APP-GW-GLR-045-NS, Revision 1  
"Nuclear Island: Evaluation of Critical Sections"  
Technical Report Number 57

**TITLE: Nuclear Island: Evaluation of Critical Sections**

## **Nuclear Island: Evaluation of Critical Sections**

The AP1000 design has been certified for application at a hard rock site. Seismic analyses of the AP1000 at soil sites are described in Reference 3. The design of Nuclear Island structures was reconciled, and if needed, updated to address the seismic analyses results of Reference 3.

**Figure 3H.5-7**

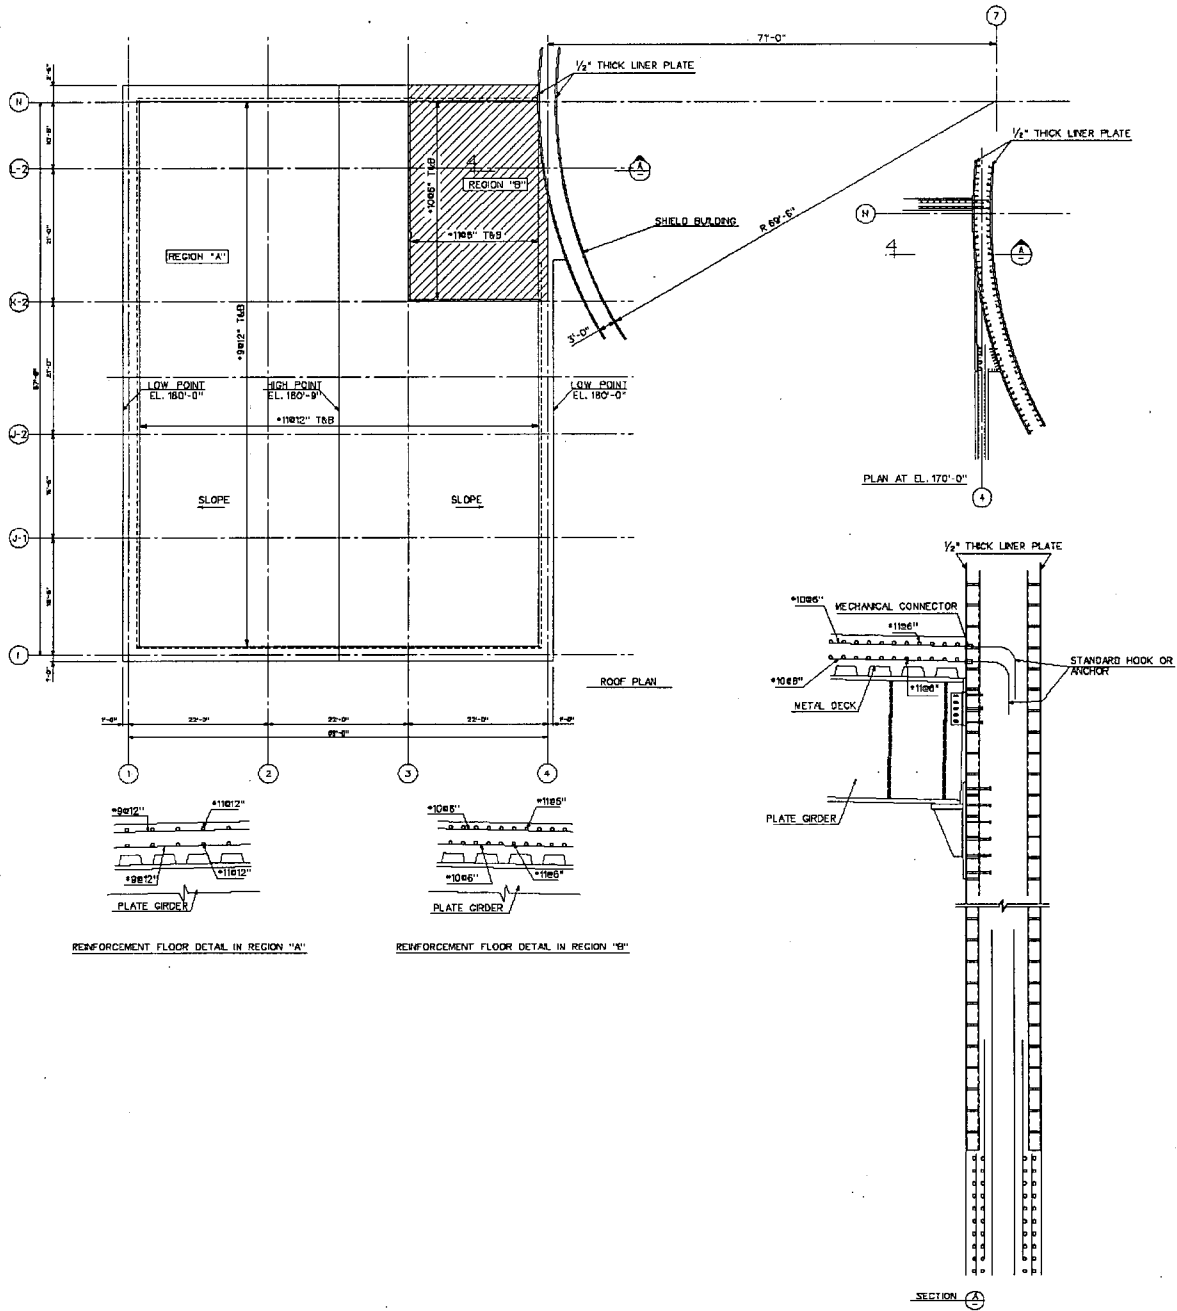
**Revise DCD Rev. 16 Figure as follows:**

Figure 3H.5-8

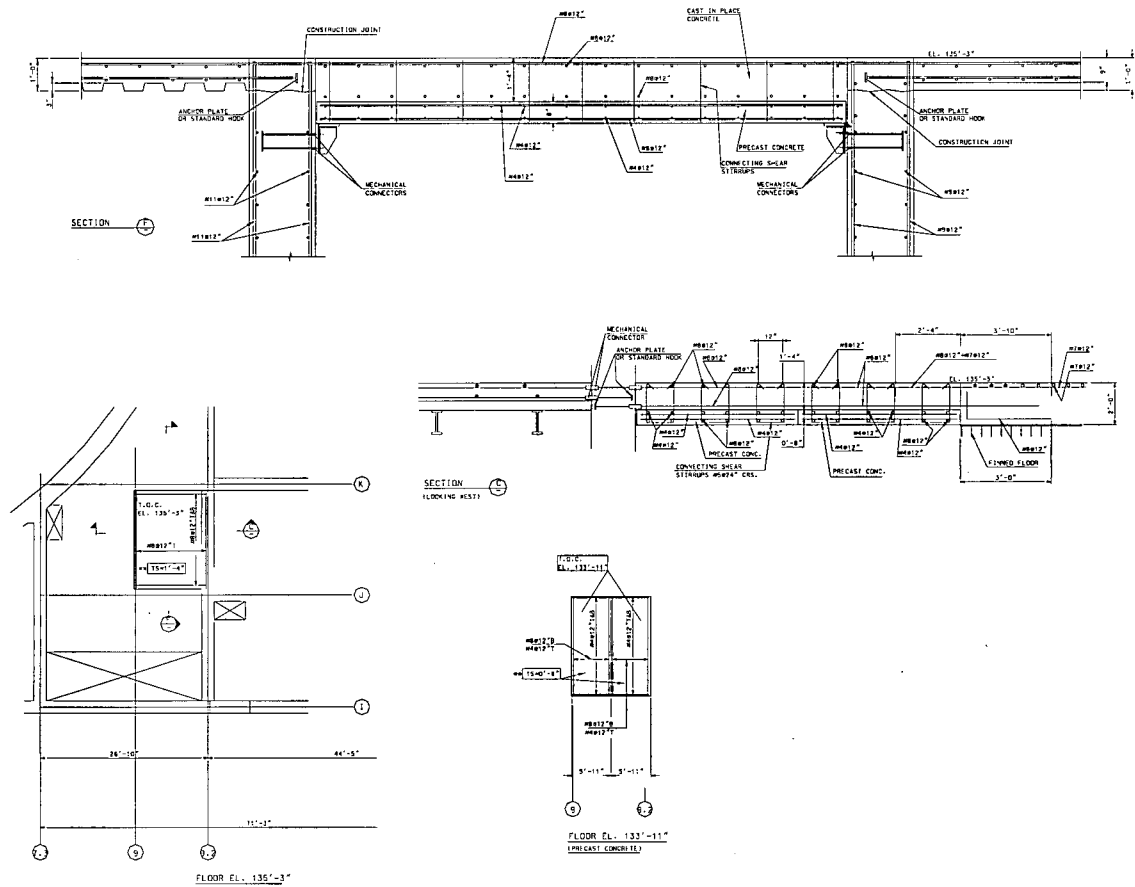
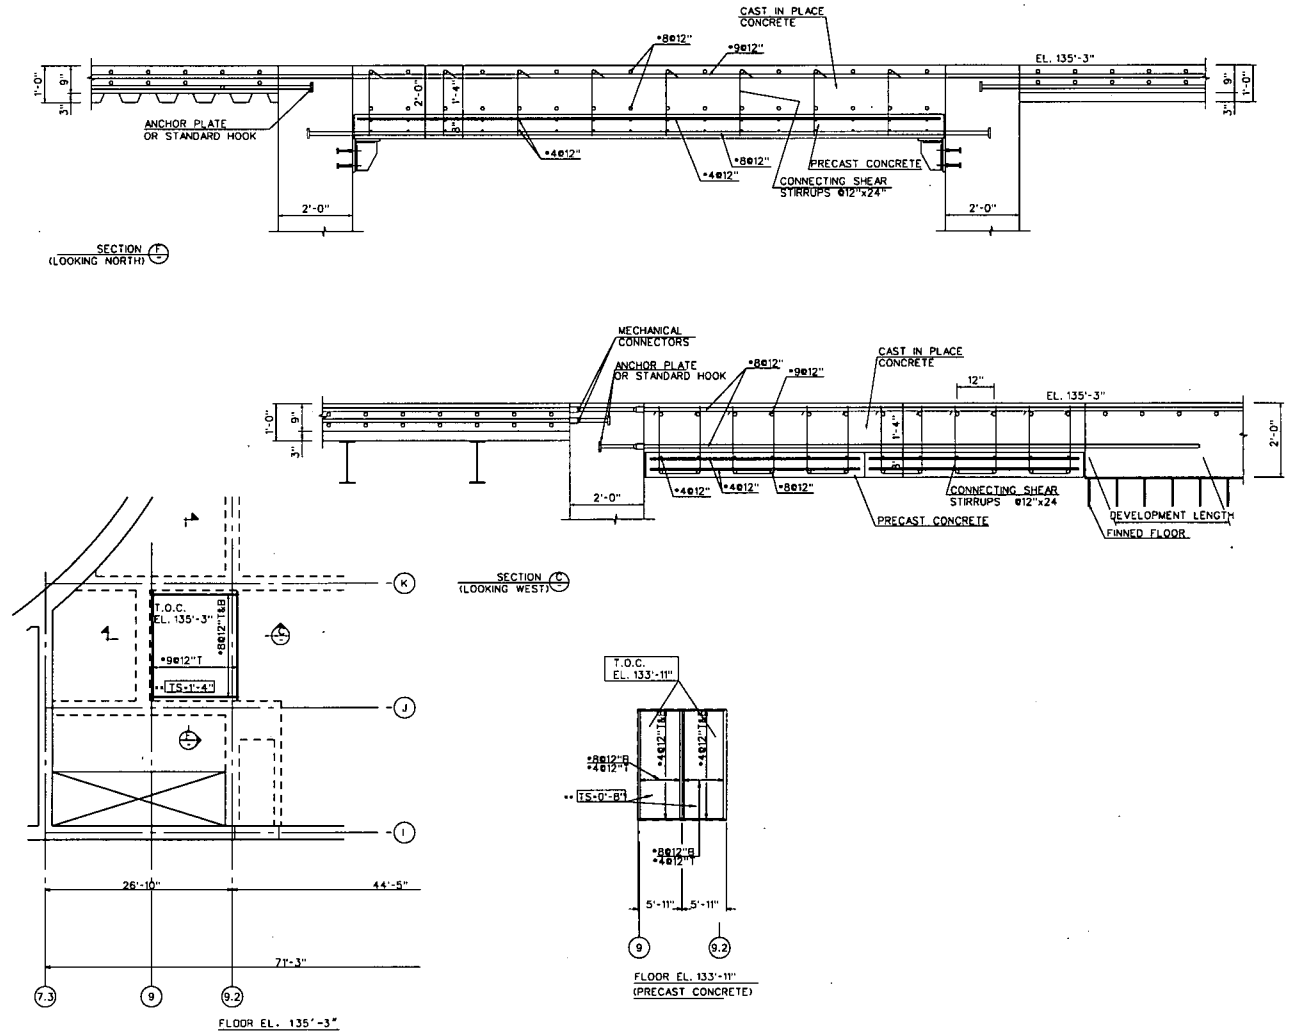
**Figure to be deleted in DCD Rev. 16**

**Revise DCD Rev. 16 Figure as follows:**
